ADDENDUM NO.: 2

DATE OF ADDENDUM: JUNE 2, 2015

**JOYNER HALL
NORTHWESTERN CONNECTICUT COMMUNITY COLLEGE
BI – CTC – 427**

CHILLED WATER PIPING RISER DIAGRAM
NOT TO SCALE

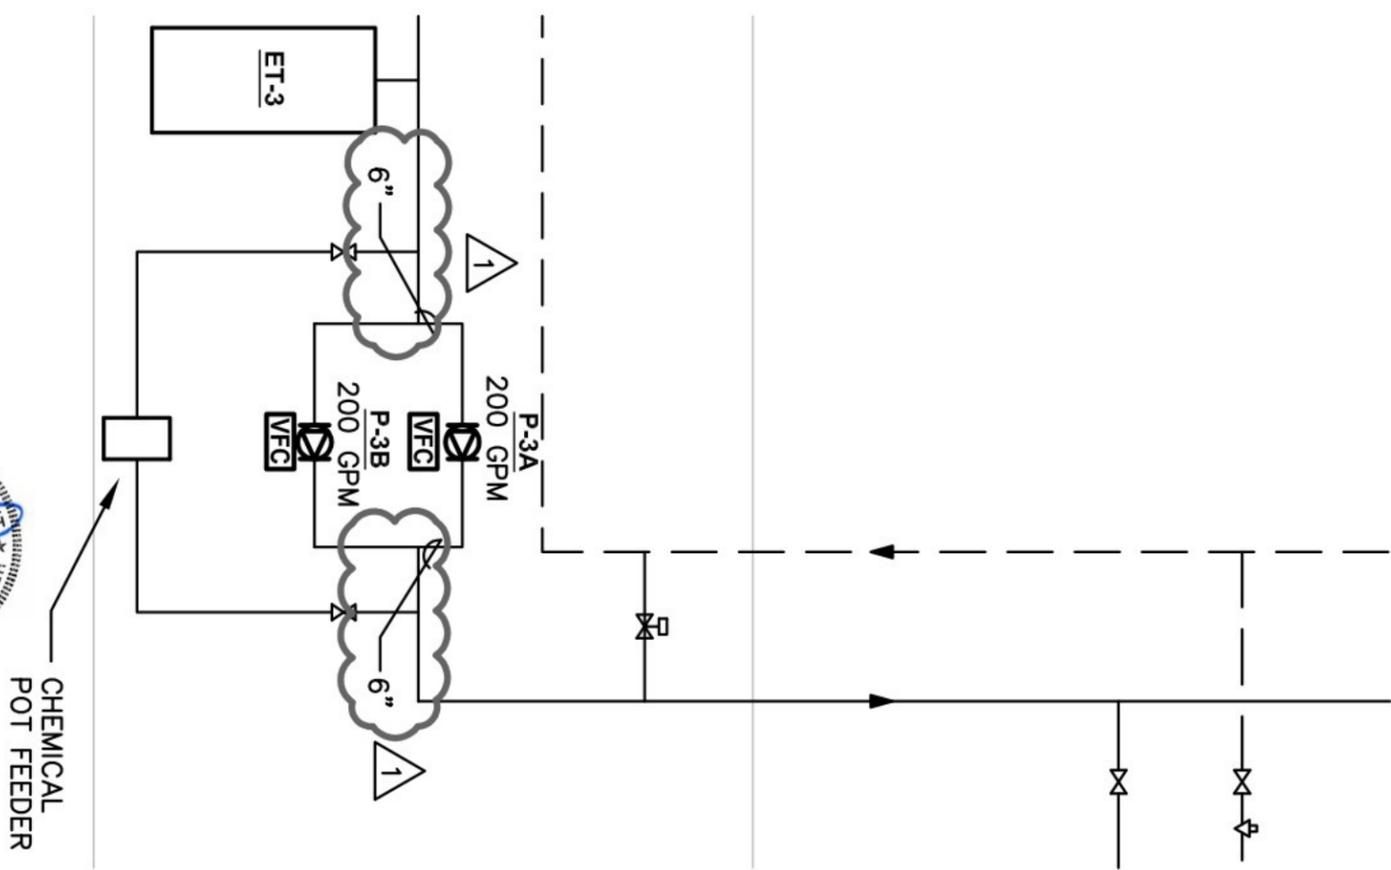
Clarification: Added pipe sizes for chiller pumps and chiller connections. Refer to sketch ADH-04 attached to this addendum.
